**Oakland City Planning Commission  
Design Review Committee**

**STAFF REPORT**

Case File Number: PLN17428 / PUDF07

# THE HUB

SHEET NUMBER **G0.7**

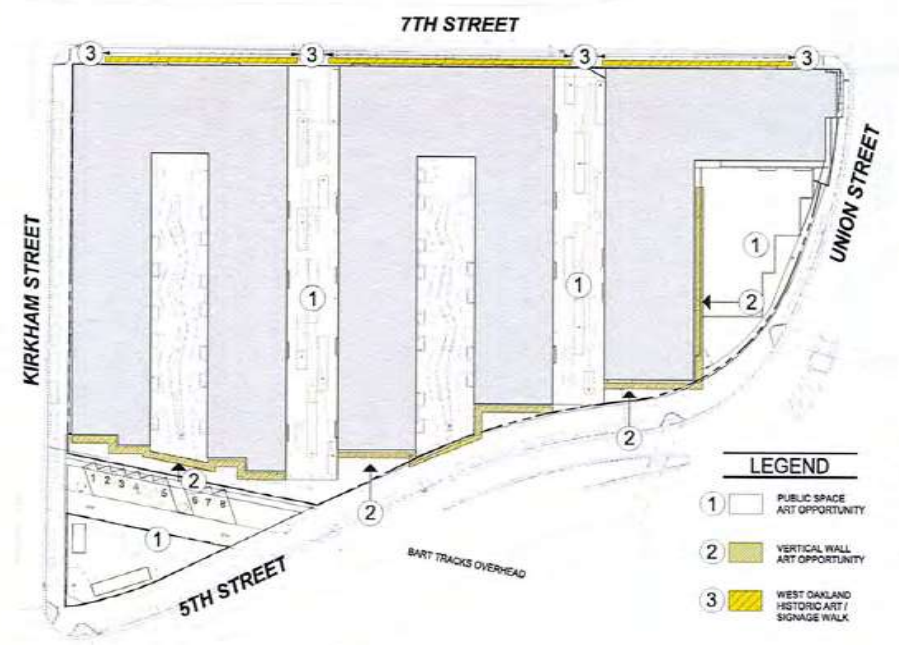
The project includes design concepts for public art within the "community gathering" pedestrian pathways and along the south and east facade of the buildings. The proposed public art range from images and other creative elements or structures. The applicant also proposes additions and/or modifications to the West Oakland Historic Art signage walk along 7<sup>th</sup> Street. These existing art works derive from the City's 7<sup>th</sup> Street Concept and Urban Design Plan by Walter Hood adopted in 2004. The intent of the Plan is to provide recommendations to reduce impacts of transportation, primarily on the 7<sup>th</sup> Street between Wood and Union Streets. The plan also recommends amenities conducive to future transit oriented development and activity with emphasis on creating a strong civic character for identity. See pages G0.7 & G0.7.1 of the design plans for details.
